**DEPARTMENT OF TRANSPORTATION
FEDERAL AVIATION ADMINISTRATION
ALASKAN REGION**

**WRITTEN RE-EVALUATION OF
JULY 2016 ENVIRONMENTAL IMPACT STATEMENT
AND
RECORD OF DECISION**

**NEW ANGOON AIRPORT REALIGNMENT
ANGOON AIRPORT
ANGOON, ALASKA**

Figure 1: Map of Five Investigated Airport Realignments of EIS Preferred Alternative

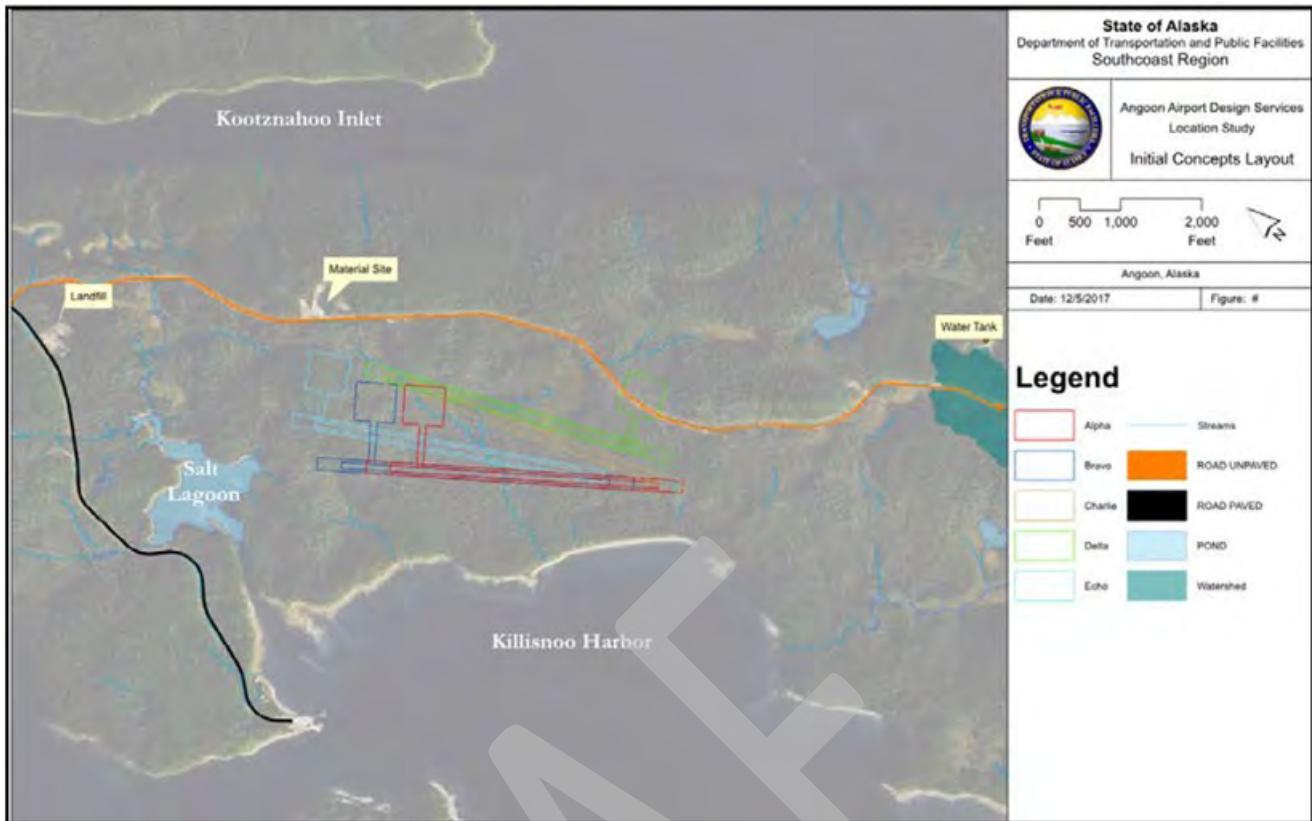
Following the issuance of the ROD, as part of the engineering/design process, DOT&PF completed more detailed geotechnical and soils analysis for the construction project. This additional analysis identified that the 2016 airport layout (EIS Preferred Alternative) had areas with unexpected construction challenges due to previously unknown soil conditions. The more extensive geotechnical/soil sampling results showed an increased amount of excavation for the EIS Preferred Alternative and limited existing on-site material resources. The EIS Preferred Alternative location had unexpected deep layers of peat associated with the creek located in the same area. The creek presented soil instability concerns. Increased excavation/fill requirements, creek rerouting and negative impacts to surrounding wetlands increased construction costs. Therefore, DOT&PF investigated several realignments of the EIS Preferred Alternative and focused more detailed analysis on four different alignments (Bravo, Charlie, Delta and Echo) in addition to the EIS Preferred Alternative (Alpha on Figure 1). Realignments Bravo and Delta were eliminated. Bravo had poor soils, poor drainage, difficult topography and was not a significant improvement to Alpha. Delta had similarities to Charlie and required additional funds to relocate roads and supporting utilities. Alpha, Charlie and Echo alignments were further evaluated based on: safety, environmental impacts and quality of design. Based on that criteria, the proposed realignment Echo was presented to FAA on January 25, 2018 for further consideration.

After DOT&PF and FAA reviewed the realignment of the Preferred Alternative and the results of this re-evaluation, the parties agreed the new layout was reasonable, feasible and prudent.

Figure 2: EIS Preferred Alternative and Proposed Realignment

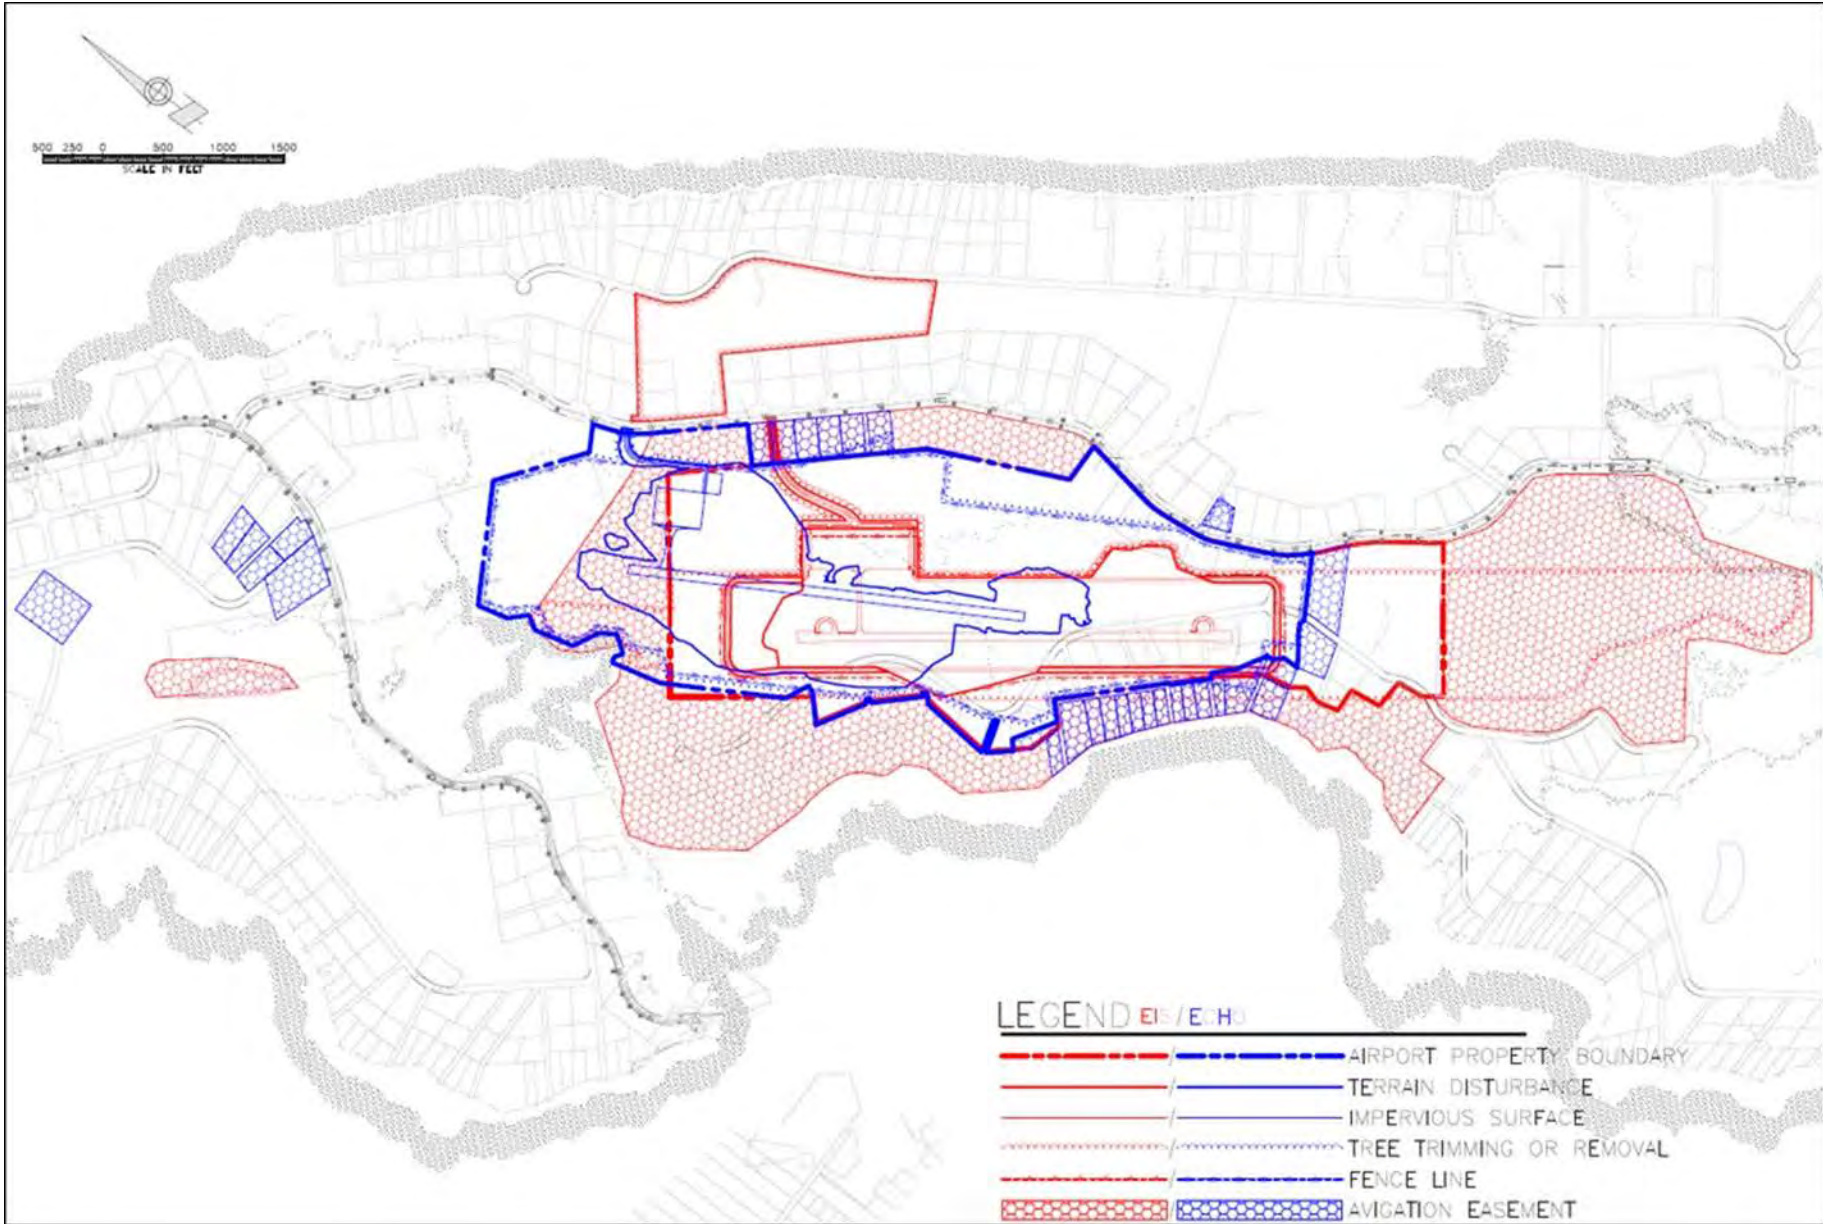
The proposed realignment of the EIS Preferred Alternative is a 1000-foot northwest shift and 8-degree north tilt from the EIS Preferred Alternative runway alignment, as seen in Figure 2 and Figure 3. There is no change to the planned navigational aids. Overall, the proposed realignment is on better drainage soils with better soil structure and reduces overall environmental impacts of the EIS Preferred Alternative. The revision is based on additional site information, primarily geo-technical data, which was not available during the EIS and provides more details of the impacts of the proposed airport layout.

Figure 3: Potential Land Acquisition Area

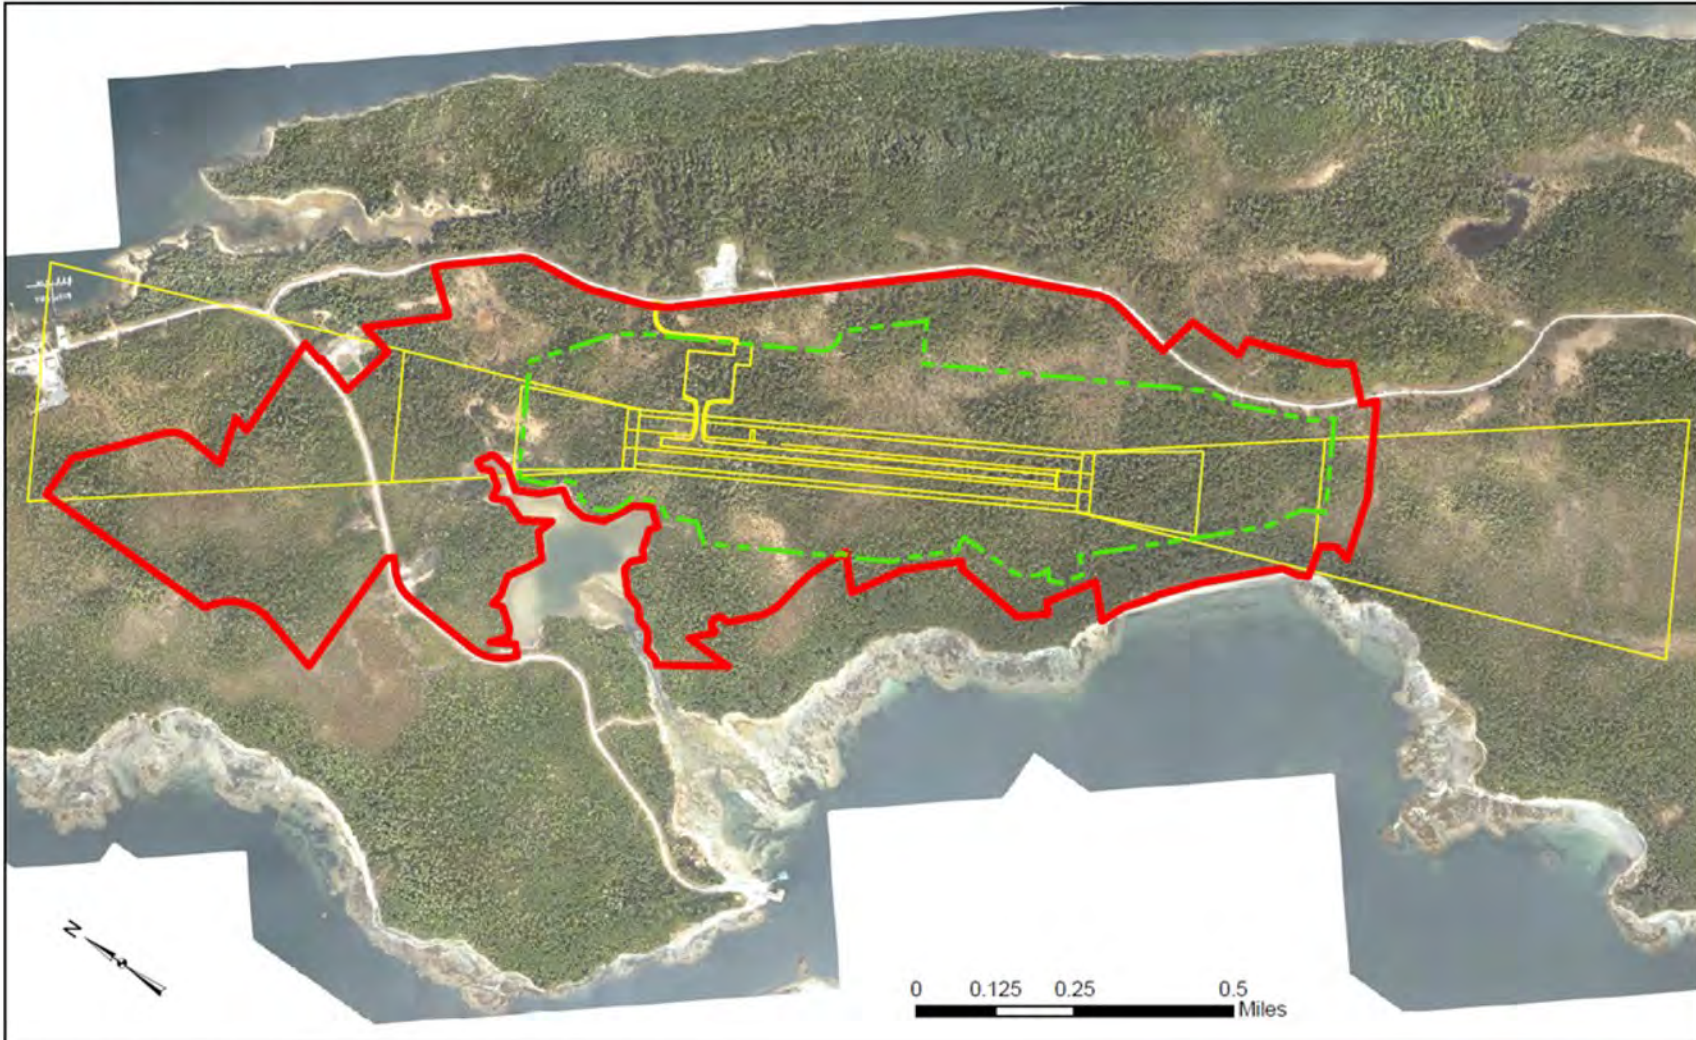
FAA Orders 1050.1F and 5050.4B require certain analyses related to compatible land use. These analyses fall into two overarching categories: 1) an analysis of effects from noise, and 2) a determination about compatible land use. The proposed realignment does not change the type or number of aircraft using the airport so there is no change to noise impacts. There are no noise sensitive areas impacted by noise. Due to the realignment, there are minor changes to areas planned for various land uses with an addition of land owned by the City of Angoon. All lands involved were the same as surveyed in the 2016 EIS, and were identified as undeveloped and uninhabited. The lands affected by the airport construction are undeveloped corporate land, privately owned land, commercial land and potential recreational land. These lands will be acquired and converted to support the new airport. Refer to the Figure 2 and the Table A for more detail on the changes to land acquisitions.

The proposed realignment will reduce land acquisitions by 10%, but it will increase the use of potential recreational land owned by the City of Angoon by 16.2 acres. The EIS determined these areas are not DOT Section (4)f properties. The extended study area contains lands owned by the City of Angoon that would need to be rezoned if acquired by DOT&PF.

Figure 4: Change in water resources impacts from EIS Preferred Alternative and Realignment

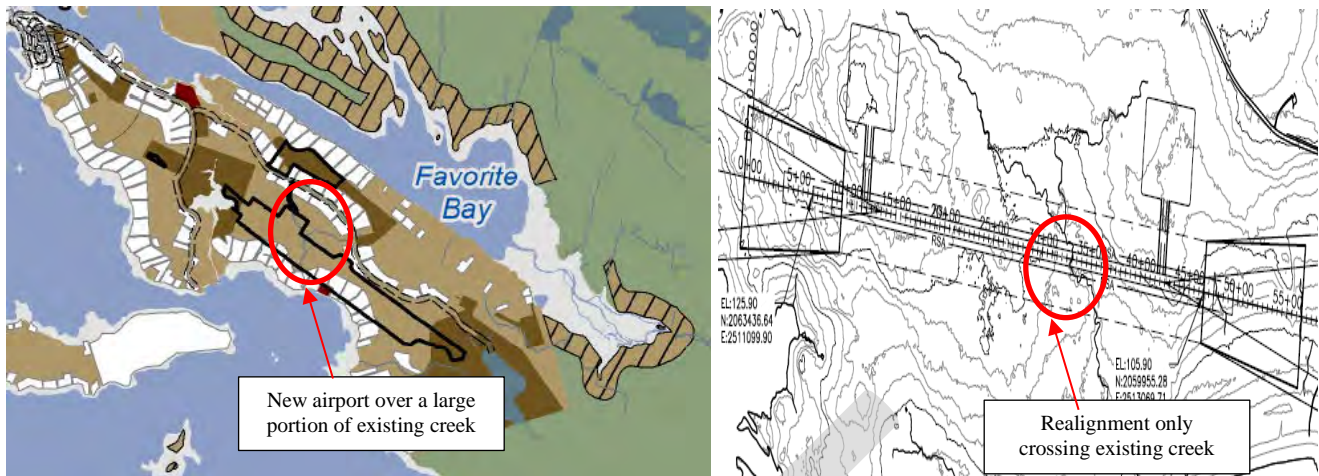
For all action alternatives, construction, operation, and maintenance of an airport and access road would affect floodplains, stream geomorphology, and hydrology. The realignment of the EIS Preferred Alternative and its apron location will further reduce the impacts on water resources in the area surrounding the Angoon community. There are no changes to the number of streams impacted and changes in peak discharges would not change from the impacts disclosed in the EIS. However, there is a reduction in acres of impacted stream channel area, from 1.2 acres to 0.38 acres, directly affected through culvert placement, rerouting, filling, or installation of bridge piers. Further review of hydrology and geotechnical conditions, as well as the existence of challenging soils, has determined that the use of a bottomless arch culvert design may not provide the necessary service life as originally disclosed in the EIS. The project is now taking into consideration other design options in order to provide a comparative analysis that would aid in determining the optimal design for conveying the stream under the runway. Comparable designs will adhere to the ADOT/ADF&G Memorandum of Agreement and current USFS Stream Simulation design protocol in order to maintain fish passage. All comparable designs will include appropriate revegetated riparian area, flood plain width, stream gradient, and natural substrate to mimic the existing conditions as closely as practicable.
